# Town of Breckenridge Planning Commission Agenda

Tuesday, September 1, 2009 Breckenridge Council Chambers 150 Ski Hill Road

## PLANNING COMMISSION MEETING

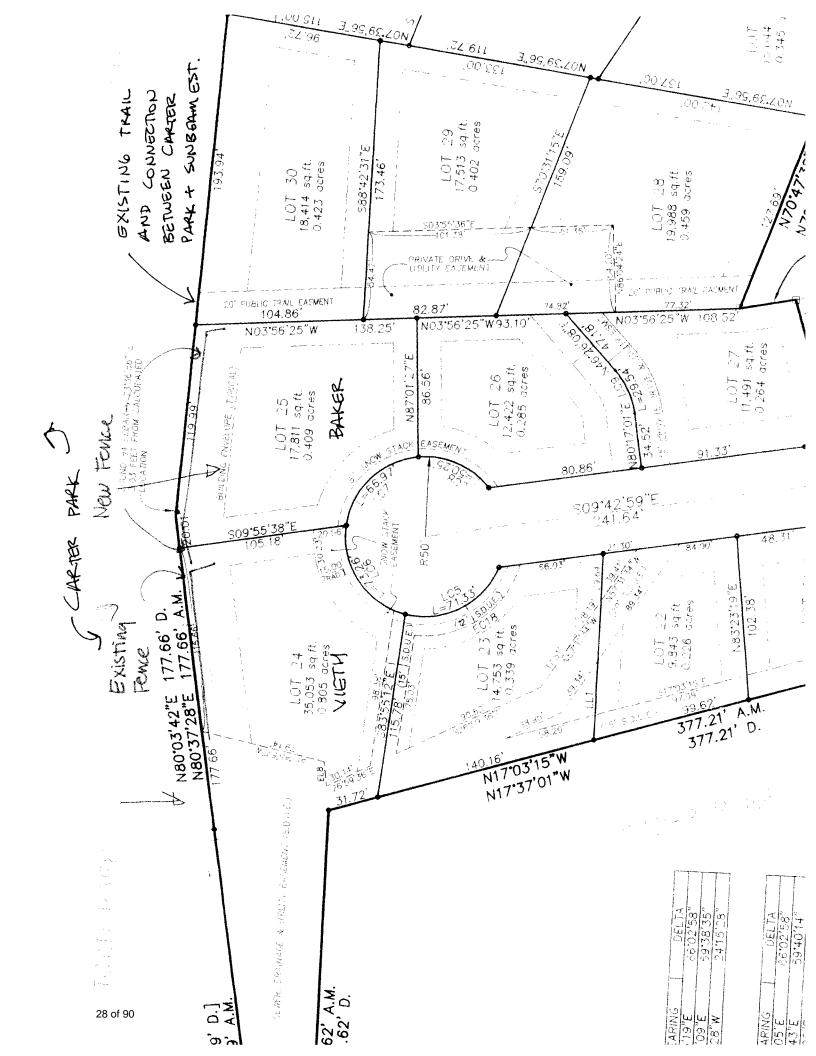
Additionally, a social trail has been created on Lot 25 at the end of the cul-de-sac cutting through the existing plantings towards the park.

K. The planning commission or town council may authorize the erection of a private fence to delineate the boundary between private land and a public trail or public open space by granting a variance from the limitations of this policy. A variance shall be granted under this subsection J only upon the written request of the applicant, and a finding that the applicant has satisfactorily demonstrated that: 1) the fence is needed in order to reduce public confusion as to the location of the boundary between the applicant's land and the public trail or public open space; 2) the applicant's inability to erect the fence would present a hardship; and 3) the purposes of this policy will be adequately served by the granting of the variance. No variance shall have the effect of nullifying the intent and purpose of this policy. Section 9-1-11 of this chapter is not applicable to the granting of a variance to erect a private fence to delineate the boundary between private land and a public trail under this section.

- 10. An improvement location certificate indicating the proposed location of the fence in relation to the property line shall be submitted.
- 11. Applicant shall identify all existing trees, which are specified on the site plan to be retained, by erecting temporary fence barriers around the trees to prevent unnecessary root compaction during construction. Construction disturbance shall not occur beyond the fence barriers, and dirt and construction materials or debris shall not be placed on the fencing. The temporary fence barriers are to remain in place until issuance of the Certificate of Occupancy.

CARTER RIDGE RESIDENCE

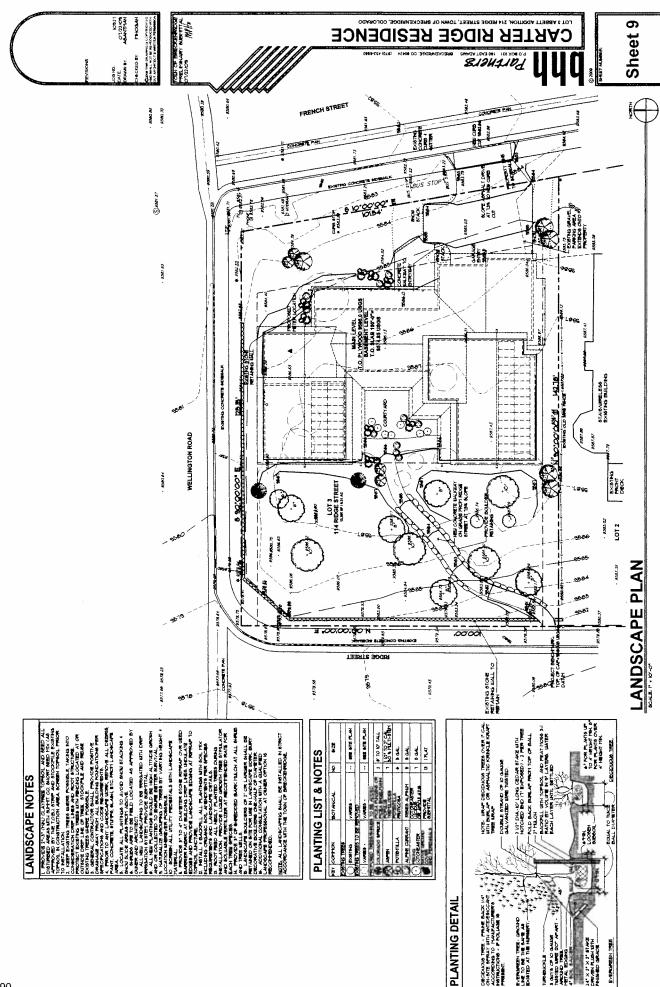
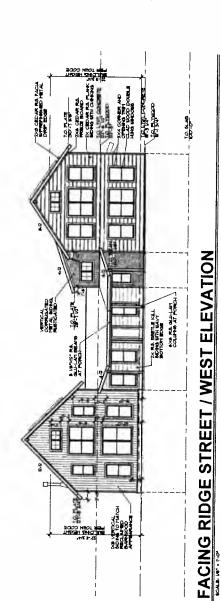
Landscaping (22/A & 22/R): It is the intent of this Policy to provide buffers between a residence, its neighbors, and adjacent streets. Staff believes that adding one or two spruce trees to the property in between the connector element and French Street would help to buffer the residence from French Street and hide the connector element so the project looks more like two separate structures. Adding one spruce tree to the Ridge Street side of the project would help to buffer the property from below. Staff did notice two trees on the property have been hit by mountain pine beetle. One of the two trees is proposed to come out due to the footprint of the residence and one would have remained but will need to be removed now. Adding a few spruce trees would help to offset the loss of lodgepole pines infested with mountain pine beetle.

- 2. Does the Planning Commission believe that adding one or two spruce trees to the property in between the connector element and French Street, and at least one spruce tree to the Ridge Street side of the project, would help to buffer the residence from French Street and Ridge Street as well as hide the connector element so the project looks more like two separate structures?
- 3. Do you agree that the revision of the roof pitch of the garage would help the project to meet the intent of Policy 141?
- 4. Are the proposed two-story elements acceptable with this proposal? Do the two-story elements meet the intent of Priority Policy 142?
- 5. How does the Commission feel about the use of different materials on the north and south modules? Does this meet Policy 145?
